T ECHNICAL INFORMATION

Subject ▶ Modification of Gear Box and Addition of Felt Ring

For Models ▶ 9046

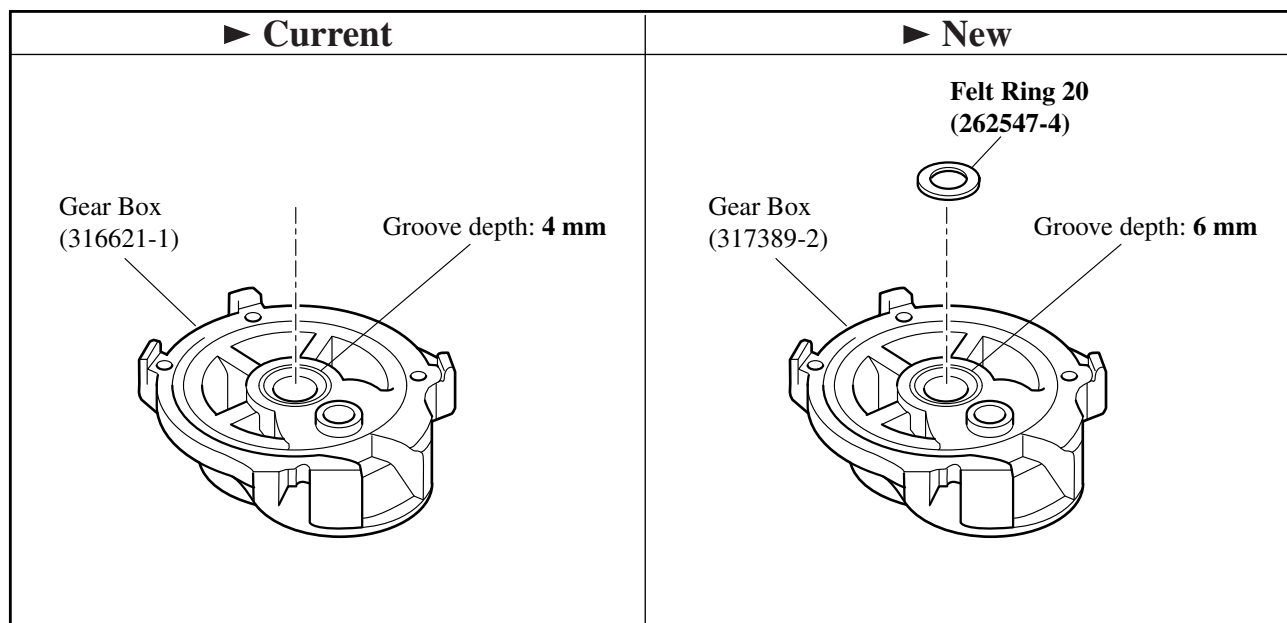
Description ▶ To enhance dust-proof performance, Gear Box has been modified and Felt Ring 20 has been added as illustrated below. Be sure to soak Felt Ring 20 with machine oil #120 or the equivalent before installing it in the Gear Box.

Item No.	Current part		Q'ty	I/C	New part		Q'ty	Note
021	Gear Box 316621-1		1	NO	Gear Box 317389-2		1	Interchangeable as a set
072					Felt Ring 20 262547-4		1
